# Washington State Convention Center Addition Project: Co-Development

Design Review Board Recommendation Meeting 01  
05-17-2016

**2 EDG 03 COMMENT  
SUMMARY**

**3 EDG 03 COMMENT  
RESPONSES**

SITE PLAN AT TERRY AVE.

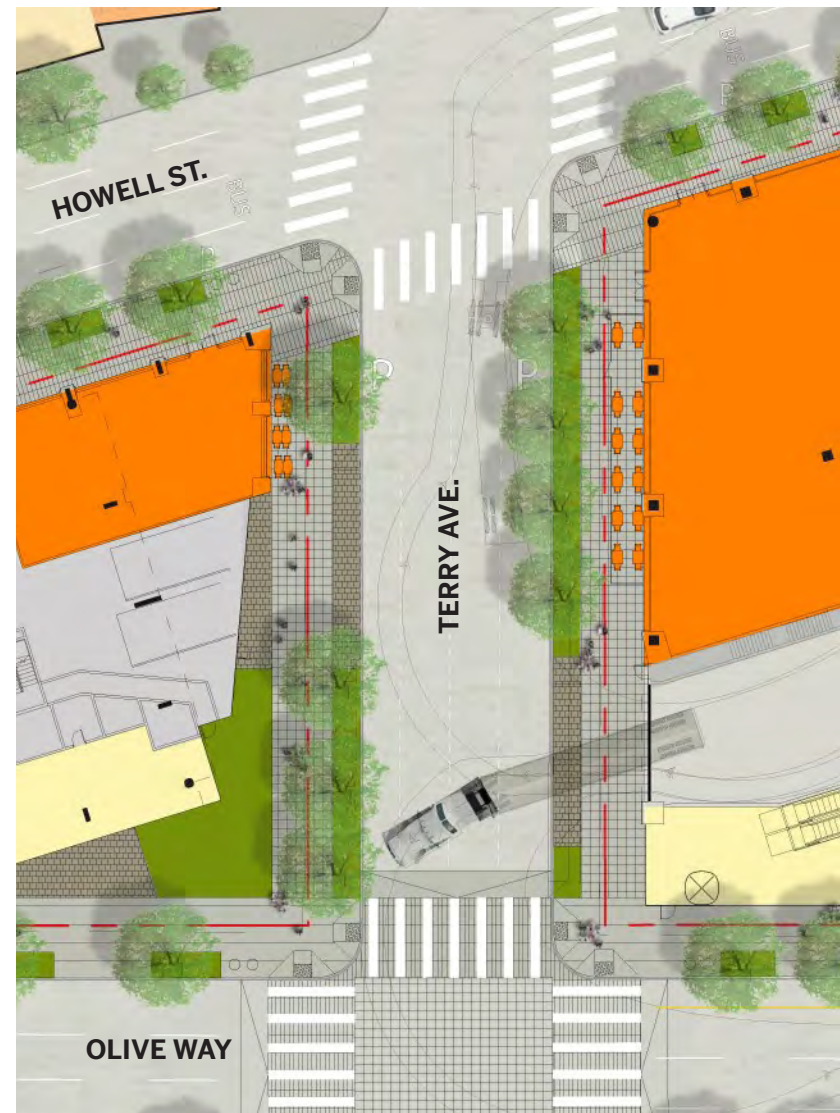
#### COMMENT 10C - TERRY AVE. & TRUCK PLAZA

The Board restated the design approach for the plaza along Terry Ave. between Howell and Olive should be pedestrian first, ensuring north/south connections when vehicles are present and creating a usable space during CCX events. Therefore, the sidewalks on both sides should be consistent connectors and generous, outside any required truck movements (which should be minimized); the sidewalks, planting buffers and setbacks shown on pg 48 were supported. The Board also restated this space is a critical visual and pedestrian link from the Terry Green Street to the CCX facility.

The Board continued to have concerns about the quantity and timing of truck movements on Terry plaza, and supported the eroded ground floor massing at Block B southeast corner, but recommended the presence of the Block B loading doors be more subordinate to the corner entrance lobby (pg 61)

**RESPONSE** - Additional views have been developed to illustrate the pedestrian experience between the Co-Development buildings along Terry Ave (pg. 25). The sidewalks along both sides of Terry Ave. provide a consistent and generous north-south connection. Wide pedestrian pathways along with a landscape buffer has been provided where possible to screen pedestrians from truck movements which have been minimized. A new pedestrian activated plaza is located at the corner of Terry Ave. and Howell Street on Site C to provide generous pedestrian nodes along the green street for adjacent street level uses. The loading doors for the proposed towers have been recessed from the buildings' facades to be more subordinate to the street level uses and lobby and reduce visual impact. Loading and service areas have been minimized to provide as much street level use as possible.

ELEVATION AT HOWELL ST.

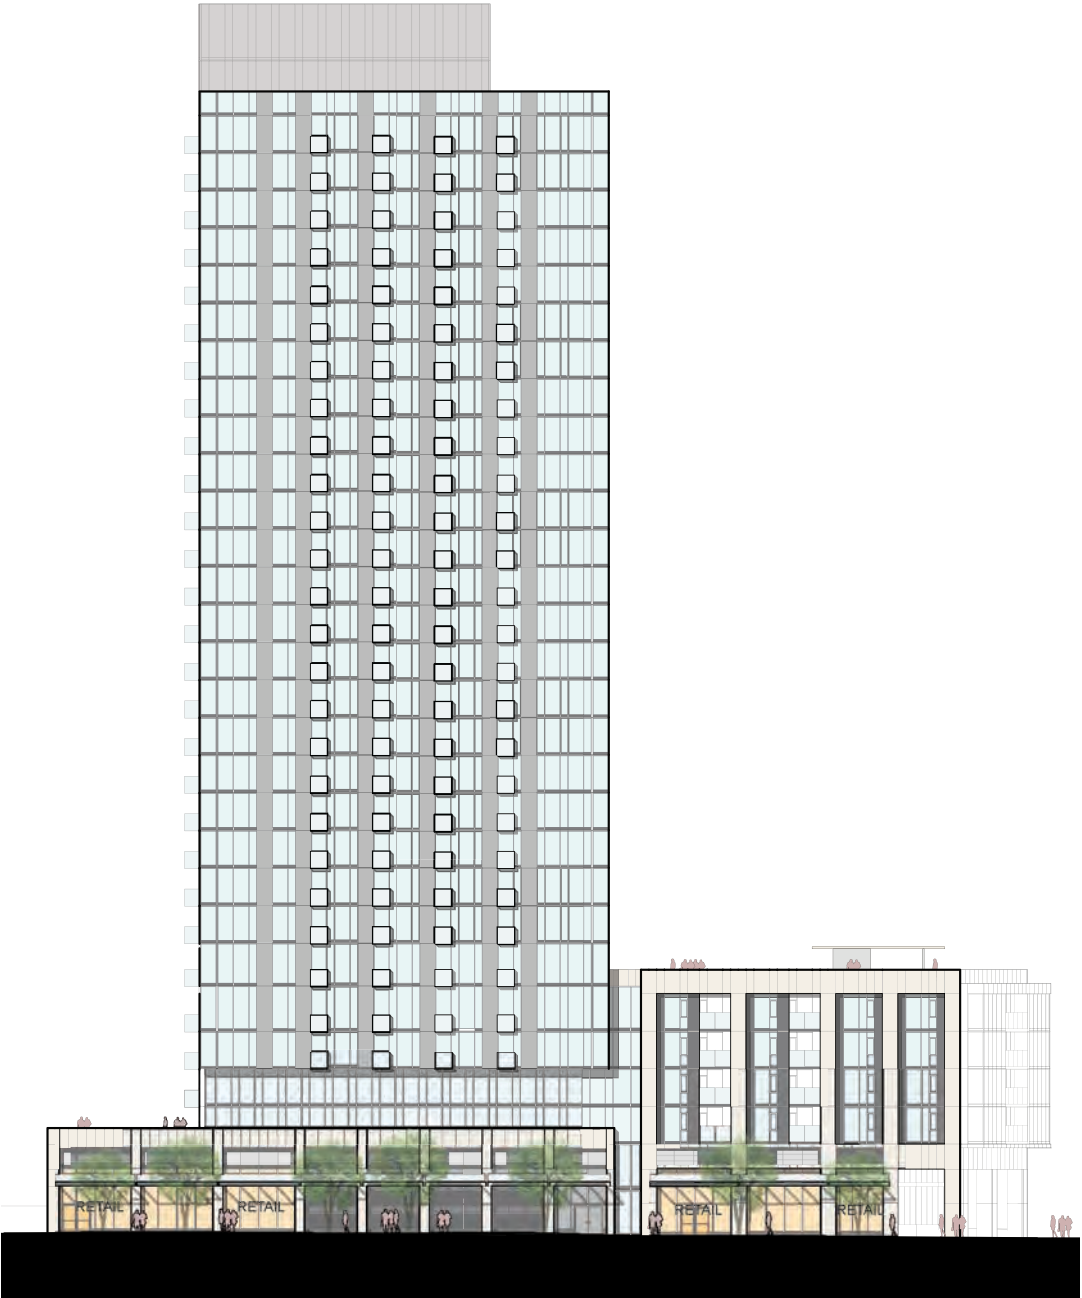
**COMMENT 4A** - TOWER MASSING AND PODIUM

**MUP 01** - Contrary to DRB endorsement of the EDG#3 elevations (EDG#3 booklet pg 60/right) and guidance to maintain “a tall podium, and expressed gasket” (EDG report 11h), the Howell tower facade runs straight down to grade, uninterrupted, leaving a compressed, residual ground level that is not the tower lobby or a use related to the tower (this tower identity-to-grade approach is valid on the Olive facade, per A310, but with further refinements). Per guidance, re-instate the basic composition from EDG pg 61, to add a legible podium, 2-3 stories in proportion to the tall mass above, and with a substantial ‘gasket’ or setback at the transition to the tower.

**MUP 02** - Carrying the tower facade language down to level 2 (on Howell and Olive) was preliminarily supported only if the rest of the podium ground floor scale was revised, and the joint/transition between the brick podium and metal panel tower is legible and well-composed. Neither has occurred; the ground level especially on Olive remains too compressed, and the tower/podium overlap is crude.

**RESPONSE** - The base of the podium has been revised to express a continuous setback at the street level. Relocating this “gasket” at the grade allowed the podium to remain at a constant height which strengthens the building mass on the site and gives more clarity to the tower and the visual transition between responding to the two forms and the influence of the street grids. The ground scale podium has been raised to create a two story expression along Olive Way. At Howell Street the ground floor scale remains at one story before transitioning to two stories as it turns the corner along 9th Avenue. A transition between the brick podium and glass tower occurs where the tower sets back for the balconies.

ELEVATION AT HOWELL ST.

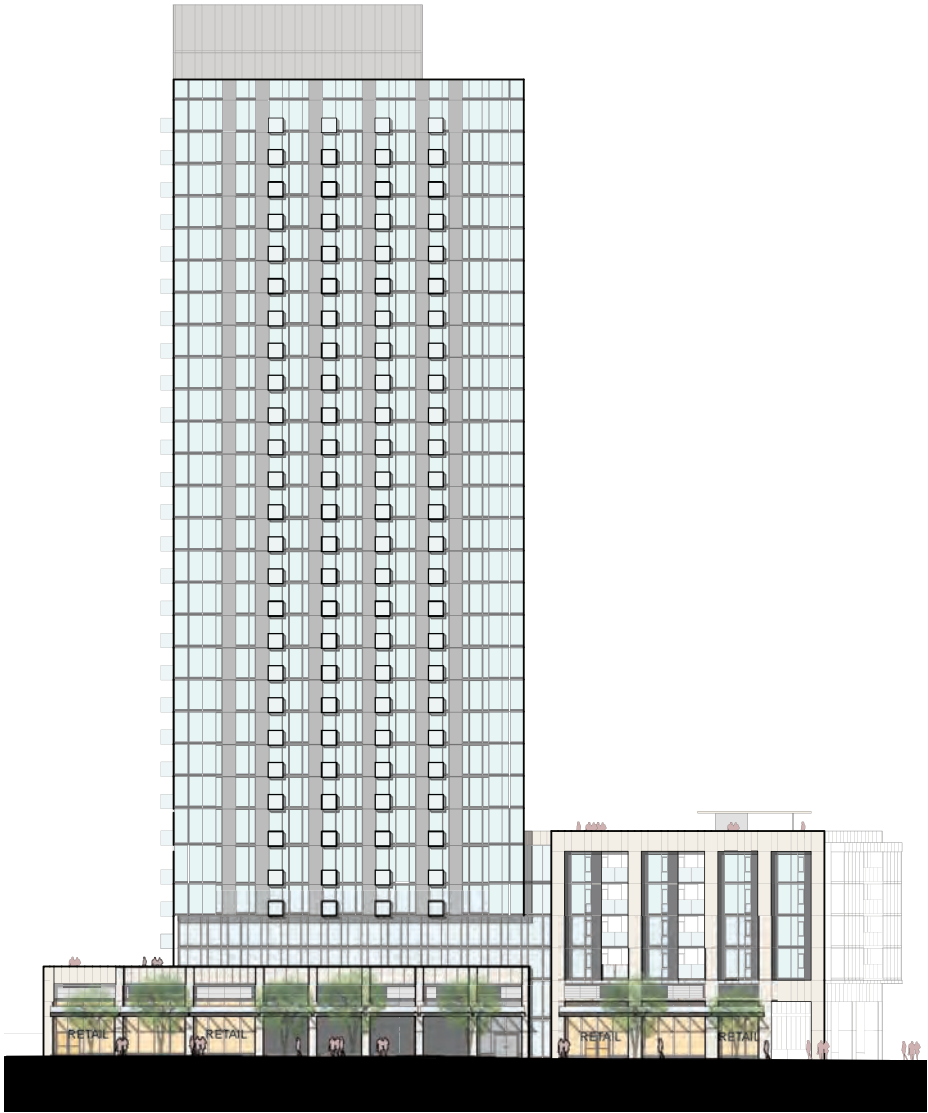
COMMENT 4B - TOWER MASSING AND PODIUM

**MUP 01** - At EDG #3 the tower above the base was broken into 2 masses with offset heights/parapets and different cladding treatments, as shown on pg 24, 60/61. The DRB endorsed pursuing this 2-part massing per guidance 10e and 11h, and did not mention a more unified, singular mass, which is now shown (elevations and G301). Please increase the roof and plan offsets to create 2 legible masses to 'slenderize' the tower, and design more dramatic elevational/material distinction to reinforce the 2 forms.

**MUP 02** - Raising a roof screen does not make 2 forms; the tower has lost all sense of verticality shown at EDG#3, it is blocky and displays no secondary slenderizing, is made up of 4 equal facades with identical proportions/materials/ colors. See g301 and elevations; revise.

**RESPONSE** - The tower proportions have been revised to give prominence to the west facing "flatiron" condition. The tower plan has remained similar to EDG #3. The facades have been redesigned to accentuate the vertical expression created by setting back the glass at the balconies. The proposed recommended design now has slender vertical expressions on all four facades, more texture and responds to the "flatiron" condition by creating symmetry and a more unified gesture at the west facade. The EDG#3 design achieved a two mass reading by raising the south and east screenwalls at the top of the tower. This gave less prominence to the "flatiron" condition which is the most visible and prominent facade of the tower.

PARTIAL PLAN AT 9TH AVE. PLAZA

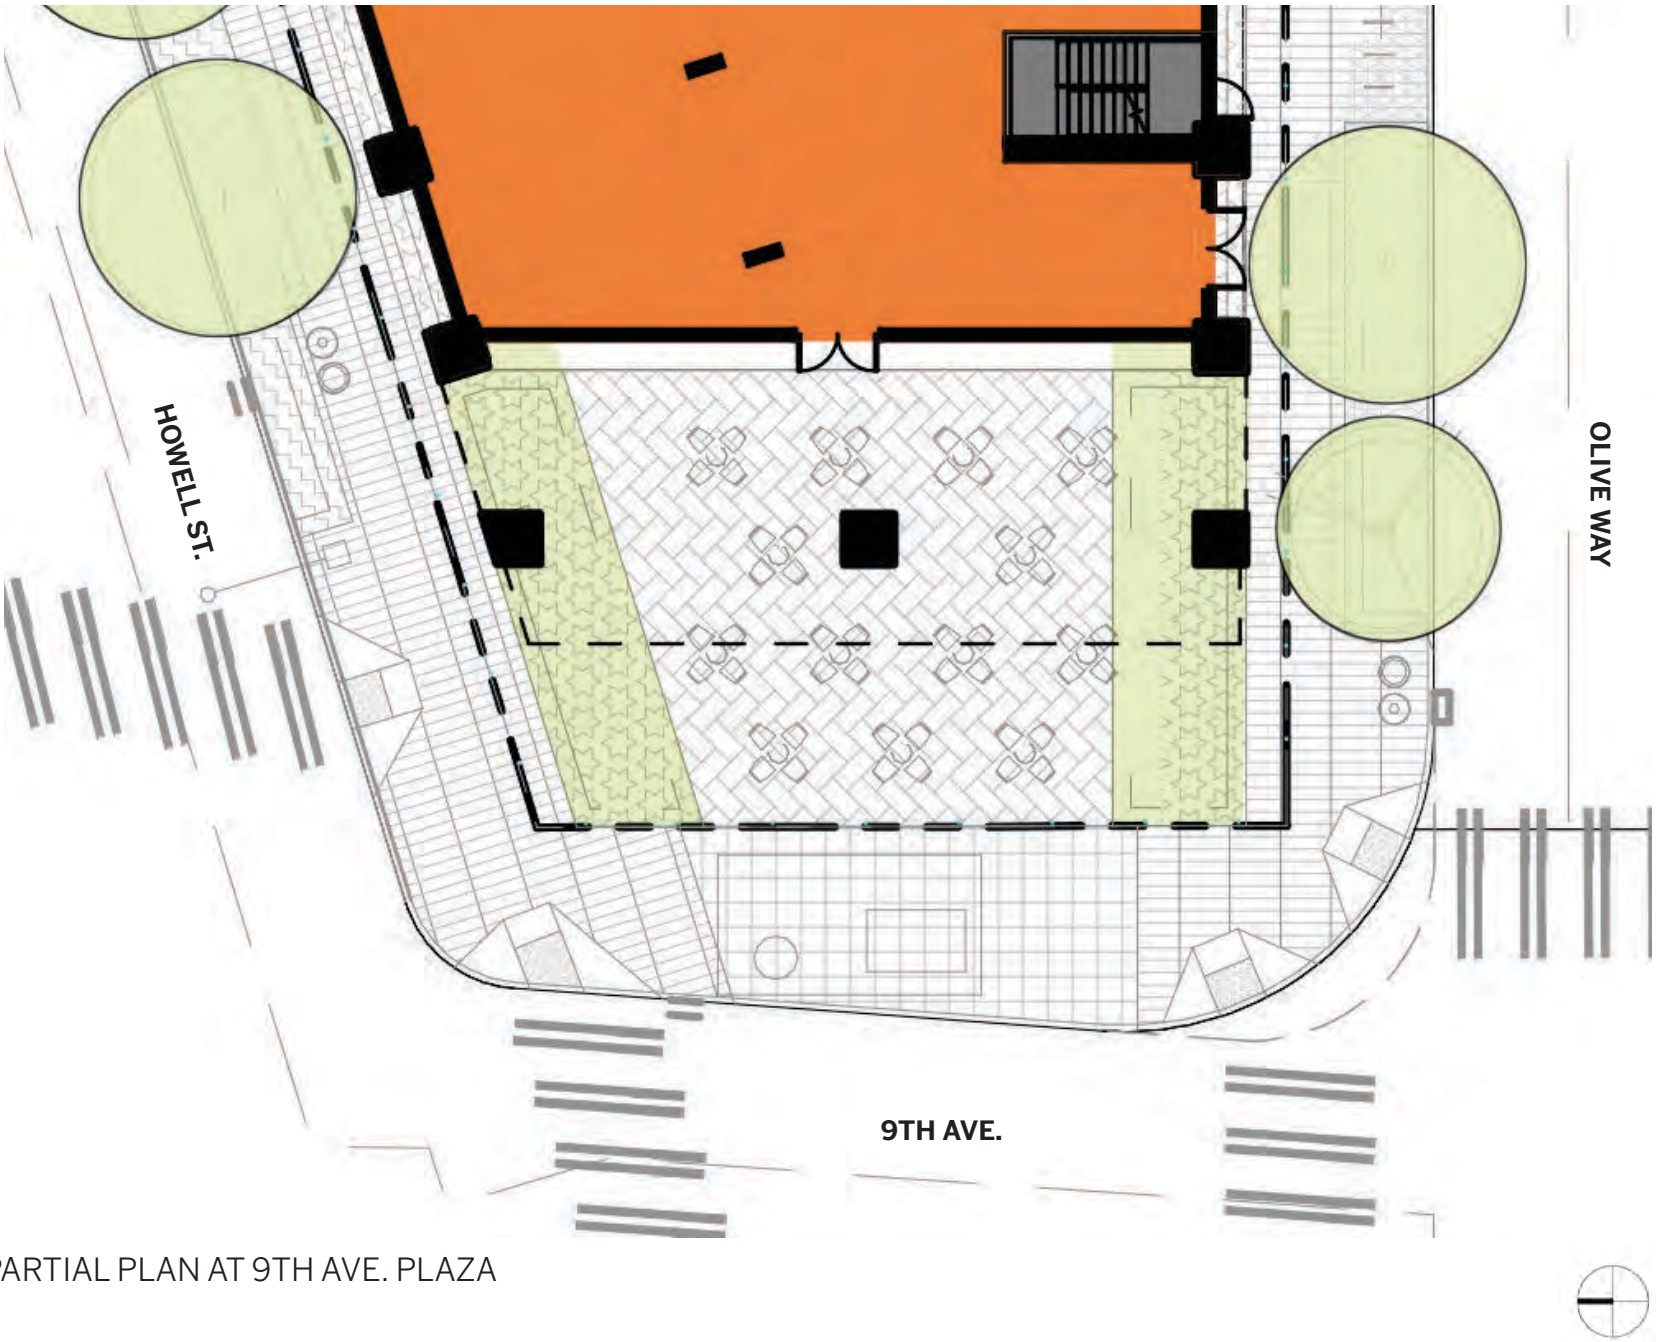
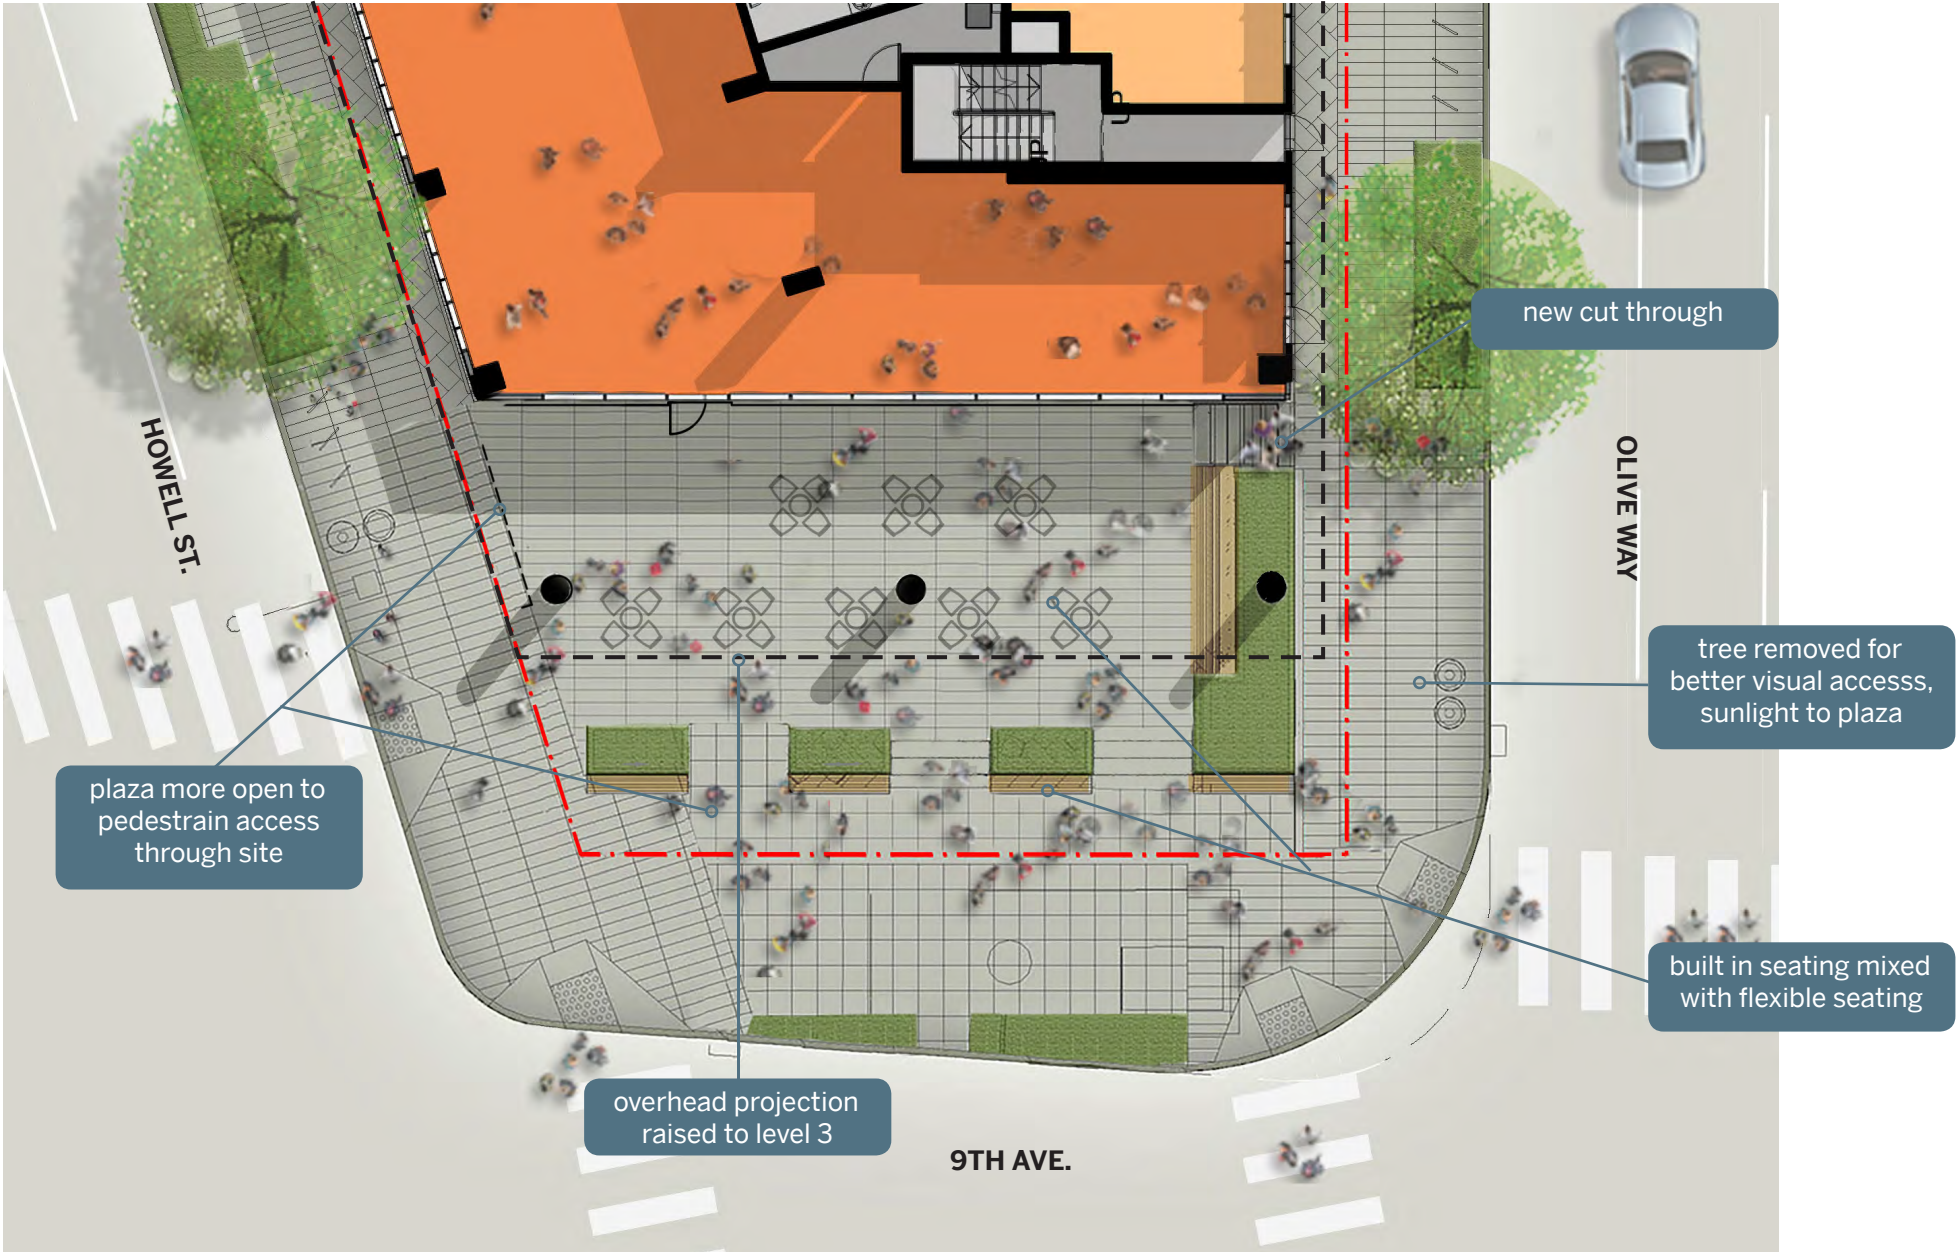
**COMMENT 5B - WEST PLAZA OPENNESS, PUBLIC ACCESS**

**MUP 01** - Per planting plan L161, 3 sides of the 'plaza' consist of a 4-12 ft wide planter, with approx 18" tall hedges, and one small 3 ft wide access apron 30 ft off the intersection; this fully privatizes the space from the adjacent sidewalks (although the perspectives on G000 show no hedges/ barriers). Eliminate/ reduce/Redesign the planters to maximize public access to the plaza and adjoining retail, especially along the west side. Revise any planter edges at the NW corner to respect pedestrian desire lines from the Howell crosswalk traveling to Olive, regardless of the PL's.

**MUP 02** - Eliminate departure #8 and improve retail viability; shift blank gas meter off the strategic southwest corner more toward mid-block (possibly in the tower return between grids RF and RG), and dogleg the exit stair corridor to provide more retail depth facing onto the plaza.

**RESPONSE** - In response to Lidsay King's email, the plaza landscape design has been revised to provide better access for pedestrians through the space. Landscape and street furnishings are designed to be open to the public while still allowing for scheduled private use.

**RESPONSE** - Gas meters have been relocated closer to a mid-block location on Howell St. to keep from street level use entrances.
